Mullica Township Government Building

Addendum 1: Narrative

LIFE SAFETY PLANS and CODE ANALYSIS

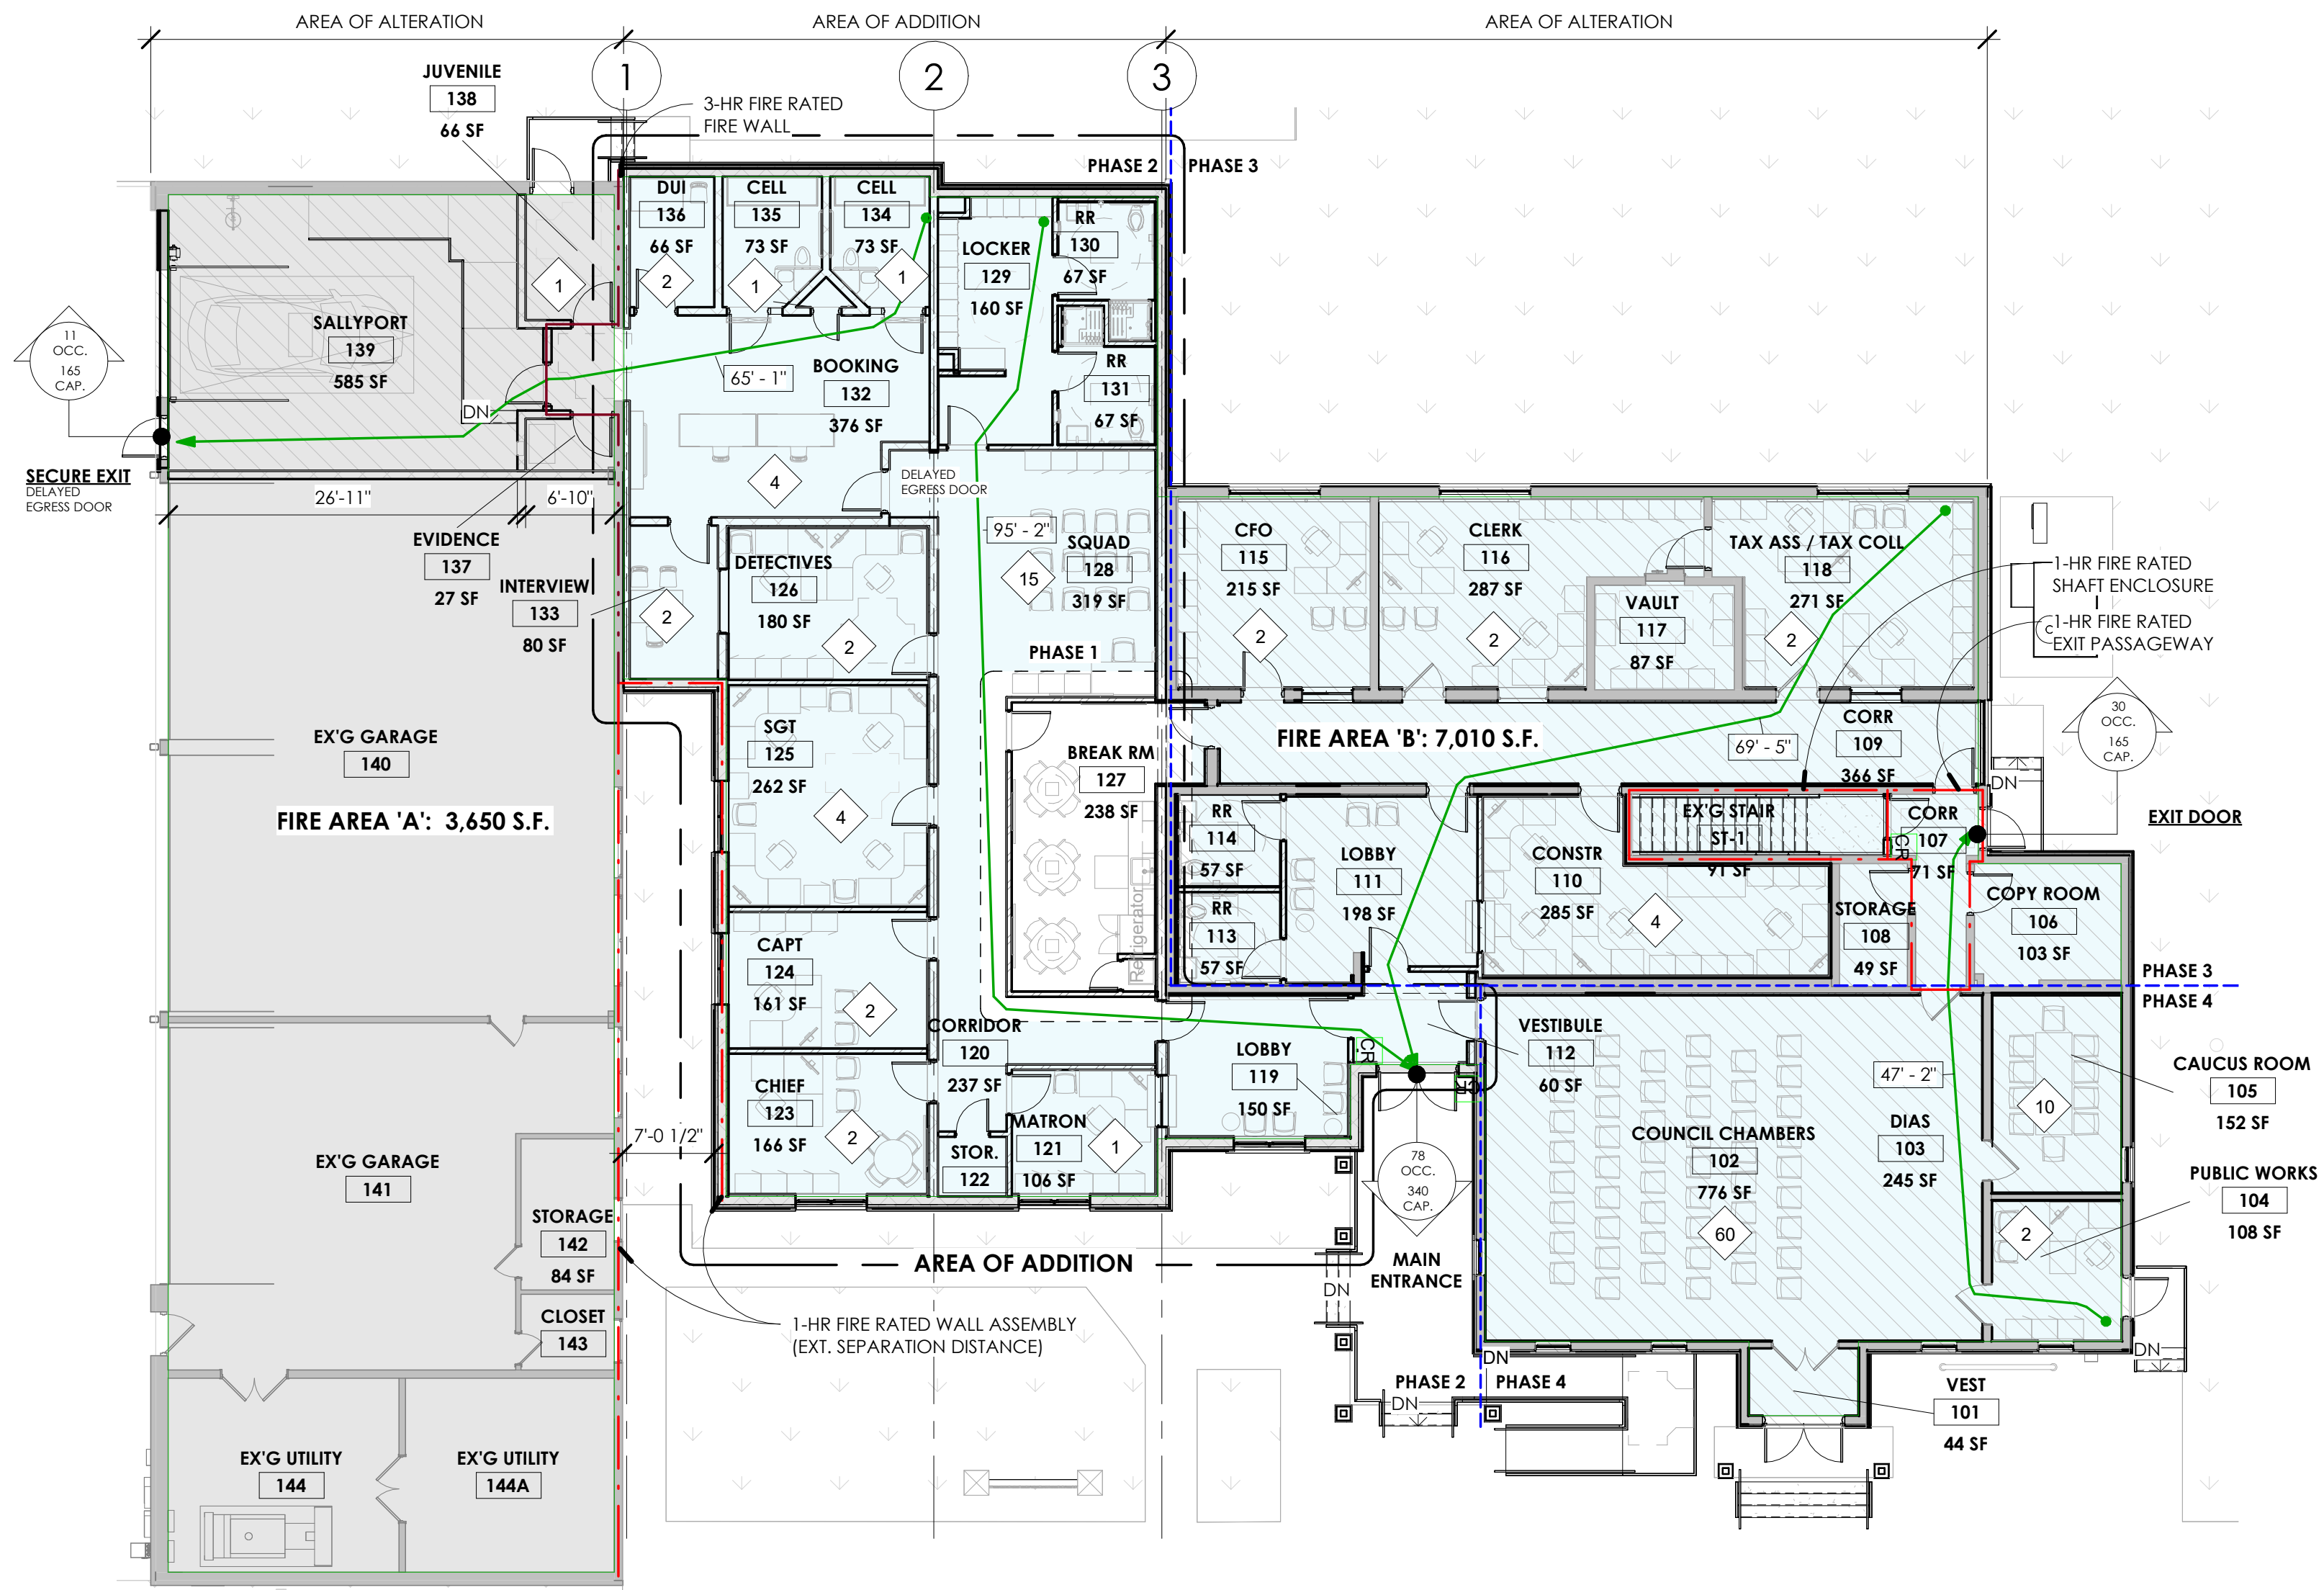
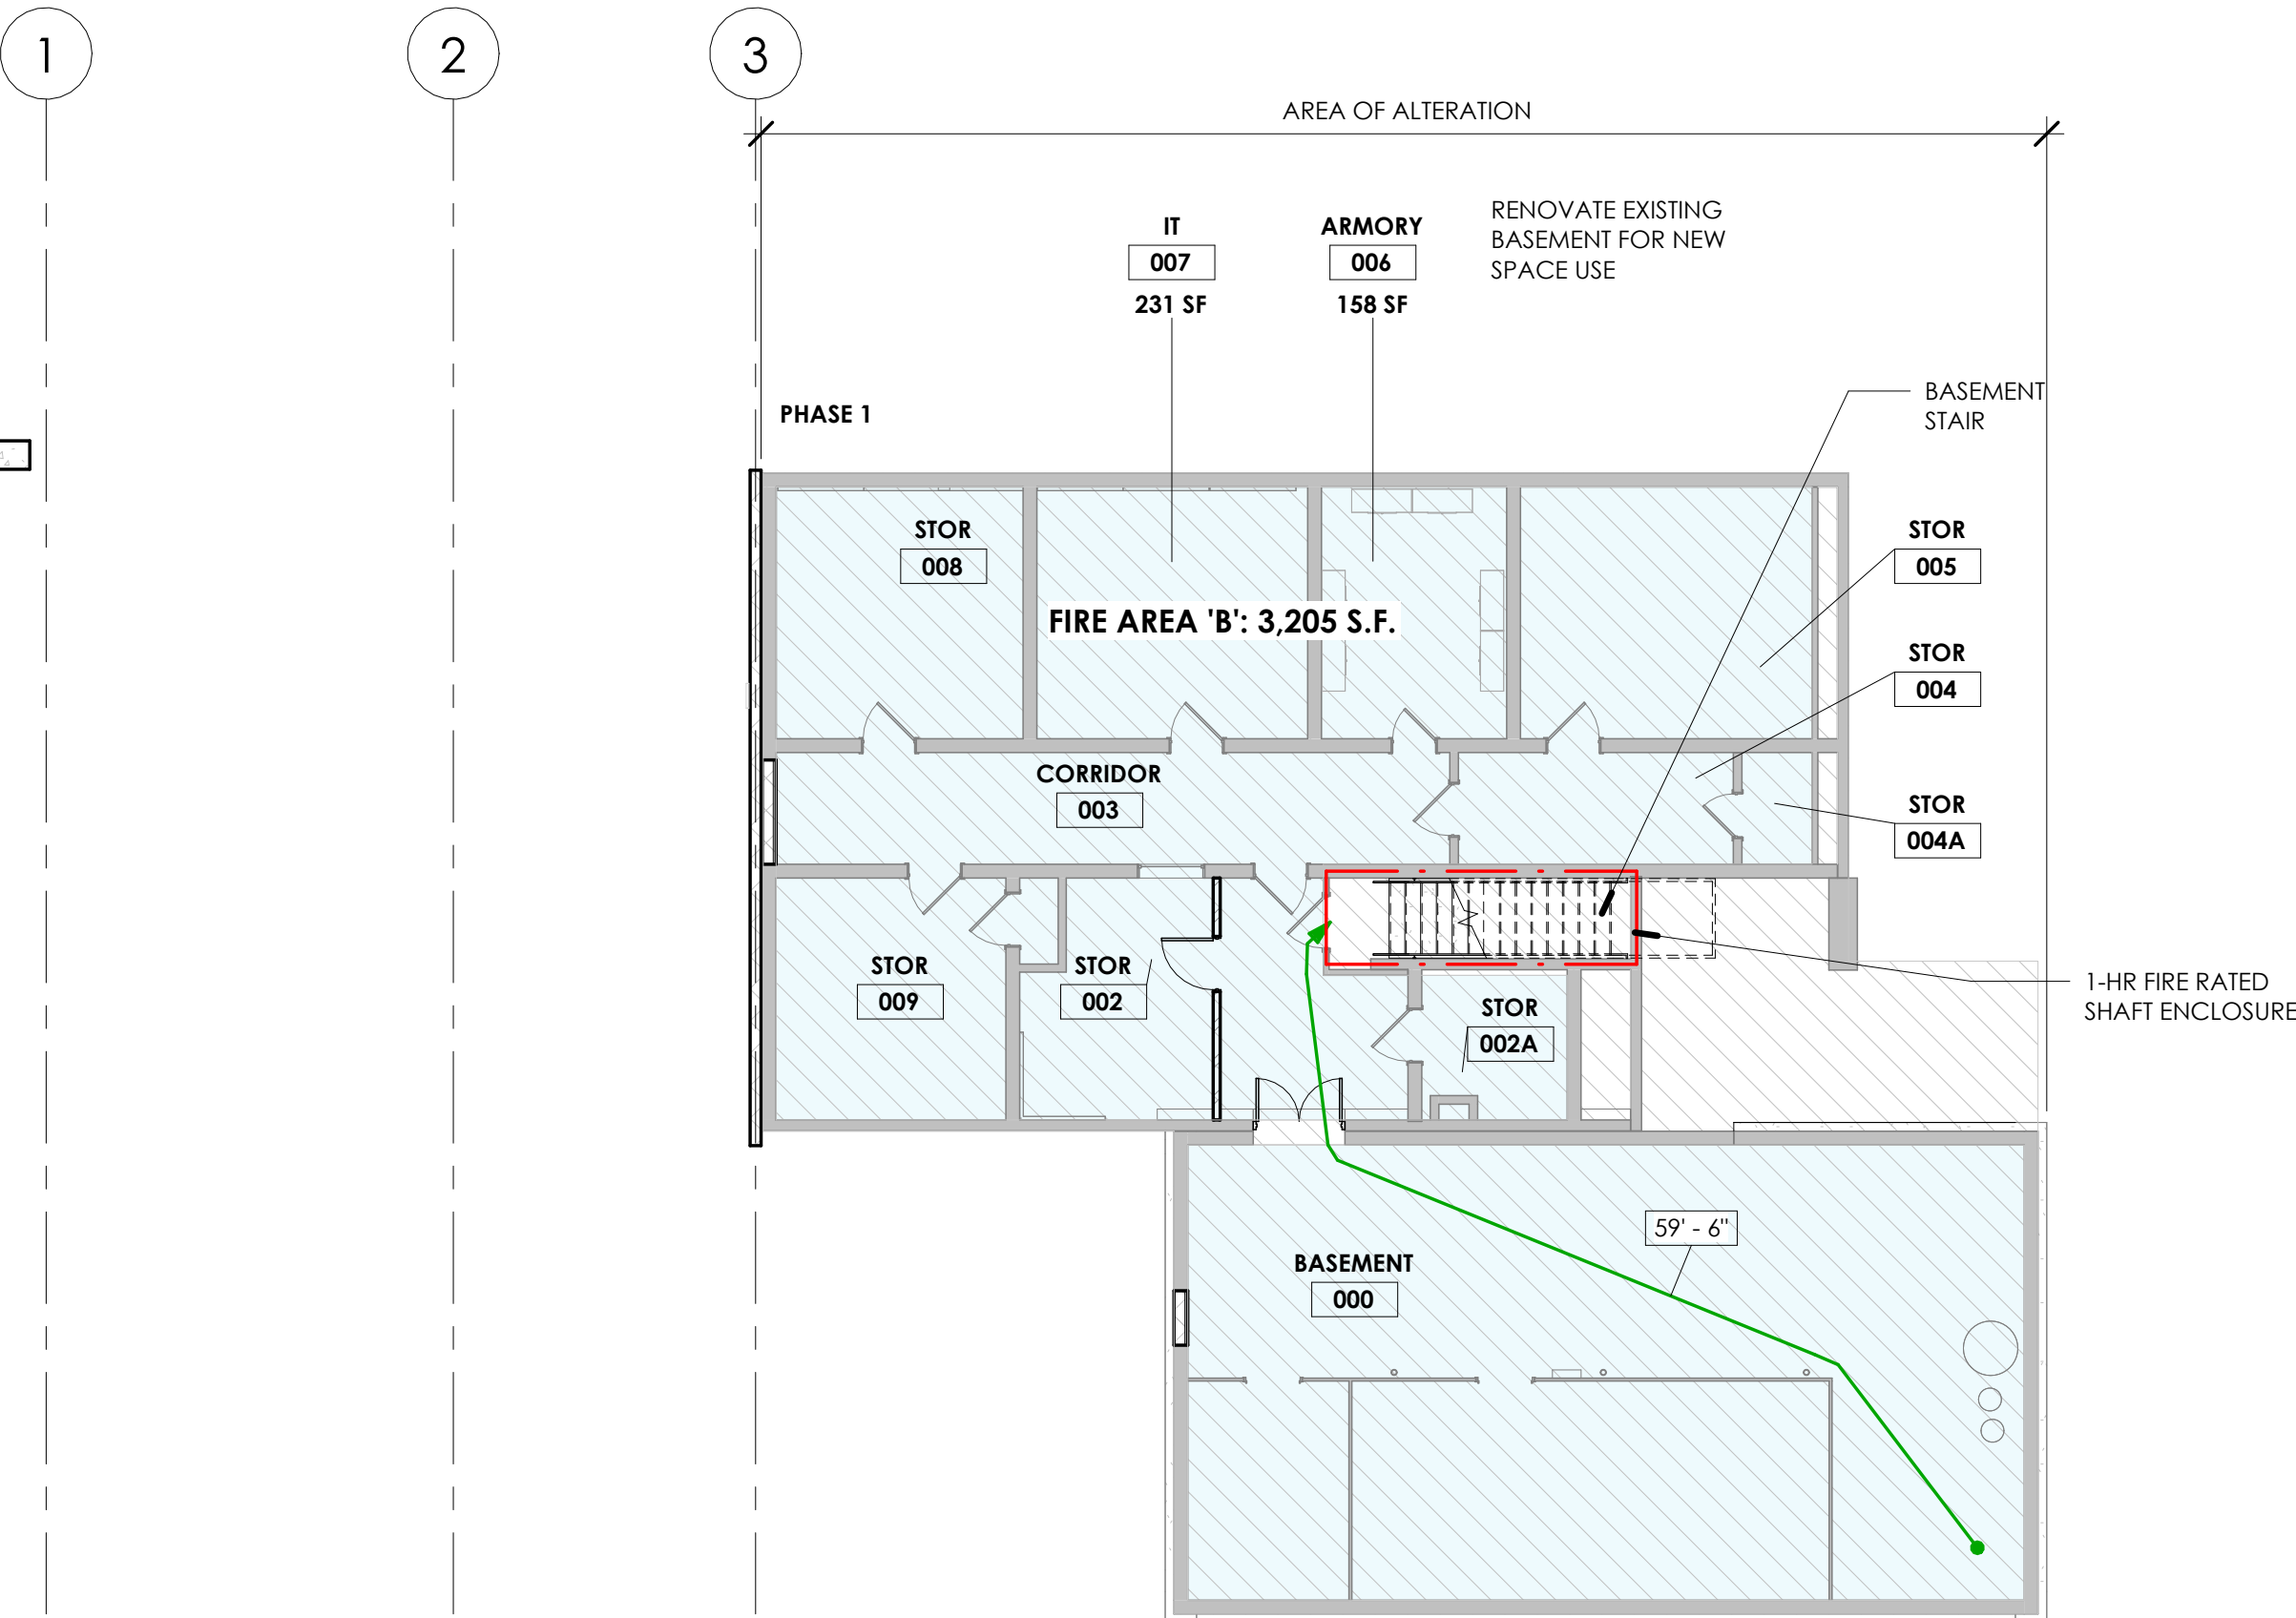
G1.01: The Building Code Analysis was updated

NUMBER	SHEET	QUESTION	DATE RECEIVED	DATE RESPONDED	RESPONSE
015	G1.01	Life Safety Notes indicate that the building is currently non-sprinklered, while code review notes reference automatic sprinkler requirements for portions of the project. Please clarify whether a new fire sprinkler or fire suppression system is required for any portion of the building or addition, including the sally port/garage area. If required, please identify the governing drawings and specification sections defining this scope of work.	07.20.26	07.24.26	A FIRE SUPPRESSION SYSTEM IS NOT REQUIRED UNDER APPLICABLE CODES AND IS NOT TO BE PROVIDED. THE REFERENCE TO SPRINKLERS ON SHEET G1.01 HAS BEEN MODIFIED IN ADDENDUM 1 TO REFLECT THIS.
016	E0.00	Please confirm whether temporary construction power will be provided by the Owner or whether the Contractor shall furnish all temporary power, including generators, distribution equipment, and associated electrical infrastructure required during construction.	07.20.26	07.24.26	CEG: Please refer to note #33 on sheet E0.00 stating electrical contractor shall provide temporary power. Coordinate all power shut downs and requirements with Township.
